**CITY OF OAKLAND**  
**AGENDA REPORT**

TO: Office of the City Administrator  
ATTN: Dan Lindheim  
FROM: Community and Economic Development Agency  
DATE: December 14, 2010

RE: **Public Hearing and Resolution Approving the MacArthur Transit Village (a) Stage One (1) Final Development Plan Permit, Which Would Allow for Development of a New BART Parking Garage and Site Infrastructure, as Part of the MacArthur Transit Village Planned Unit Development (PUD060058), Pursuant to City Council Resolution No. 81422 C.M.S. Condition of Approval #27, and (b) Vesting Tentative Tract Map 8047, as recommended by the Planning Commission**

② EAST ELEVATION  
332' - 11-0"

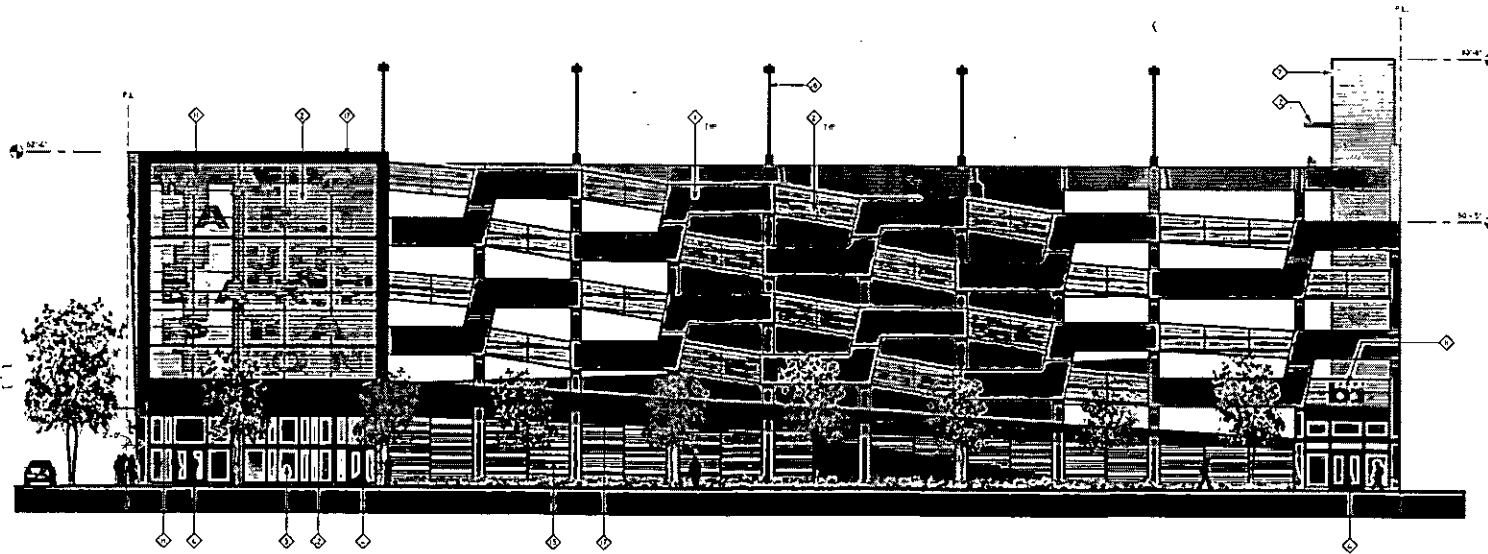
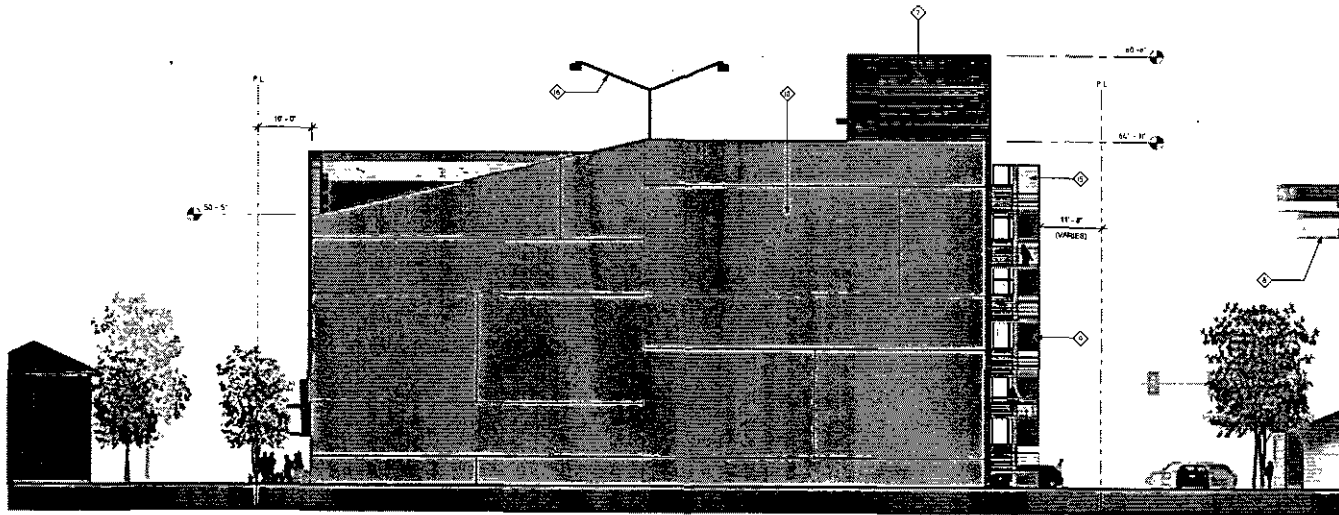
The east elevation, which fronts Internal Street, has ground-floor commercial storefront wrapping the corner, with woven metal screen above. The rest of this elevation has metal security screen at the base and alternating segments of textured and smooth pre-cast concrete panels above in a stepped pattern. See *Attachment A, Exhibit A. Project Plans*.

The prior design had a metal channel treatment at the base of the east elevation that did not appear to provide an attractive view of the garage for pedestrians. Per Design Guideline A4.4, staff suggests that the design treatment be revised to be consistent with the base of the building shown on the west elevation that includes artistic metal screens. The Applicant revised the east elevation to be consistent with the west elevation.

SHEET NUMBER  
**A3.2**

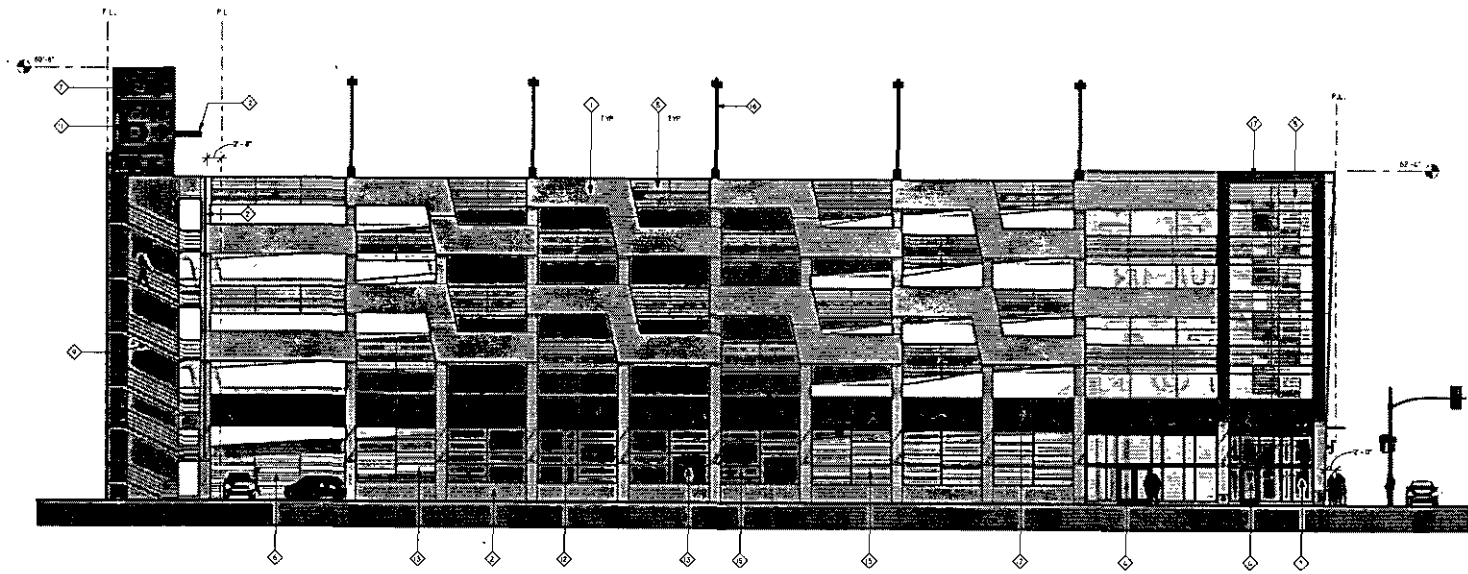
The north elevation, facing 40<sup>th</sup> Street, is a blank concrete shear wall with decorative scoring patterns and some sections of concrete block. There is no design treatment provided on this massive blank wall as it will be covered by a future FDP phase. BART and the Applicant have agreed to work with planning staff on the scoring design and will also install temporary banners with images during the interim period. See *Attachment A, Exhibit A. Project Plans*.

Staff recommends that the Applicant further articulate the north elevation of the garage in order to enhance the interim appearance of the blank shear wall. This could be accomplished in a variety of ways, including banners, mural, or paint. Although Stage IV of the project is planned directly adjacent to this blank wall, it may be a number of years before this phase is constructed. In the interim, this wall will be located adjacent to the remaining BART surface parking, and will be visible at a distance from 40<sup>th</sup> Street. BART staff has indicated that they are receptive to working with the applicant and staff to address this wall during the interim time period before the adjacent development is built. The current proposal includes scoring of the wall in a varied architectural pattern responsive to the irregular window mullions currently proposed for the building's ground floor.
